ADDENDUM

Project Name: High School HVAC
Silverton I.S.D.
700 Loretta Street
Silverton, Texas 79257

Addendum No.: **One (1)**
Date: August 7, 2009
Project No.: 09098.1

SUPPLEMENTAL DRAWING NO. SD-2

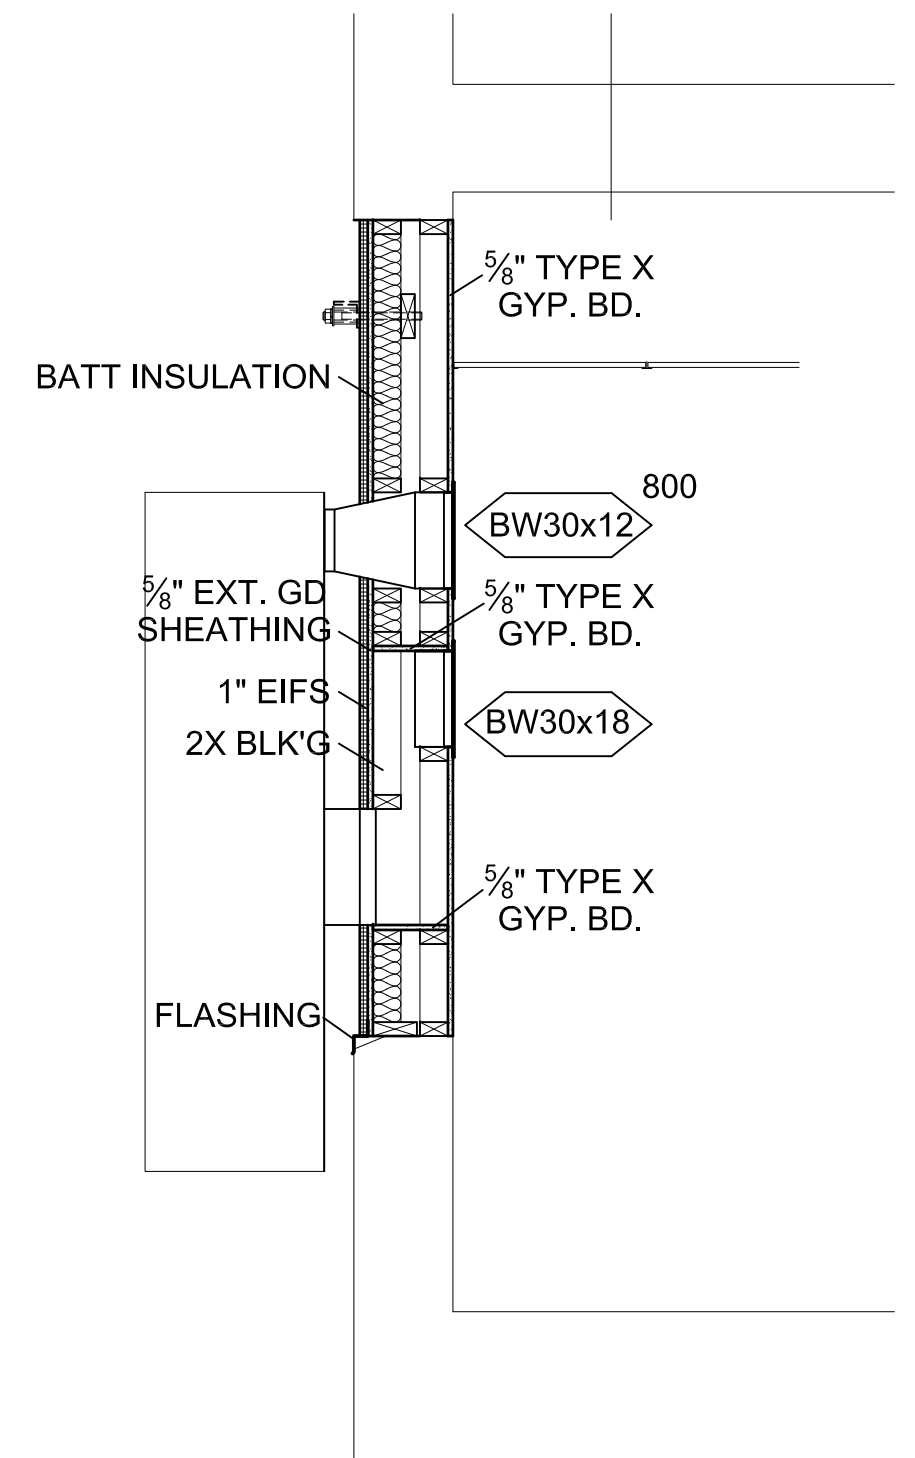
- A. Provide window in-fill at wall mount units as shown on Supplementary Drawing SD-2 attached herewith.
- B. Provide new furnace and coil as scheduled on Supplementary Drawing SD-3 attached herewith.
- C. For clarification purposes the furnace and coil “F&C1” shall have a coil compatible with the new R22 condenser already installed. The furnace and coils “F&C2 and F&C3” shall have coils compatible with R410A refrigerants that will match the new R410A condensers the school will provide.
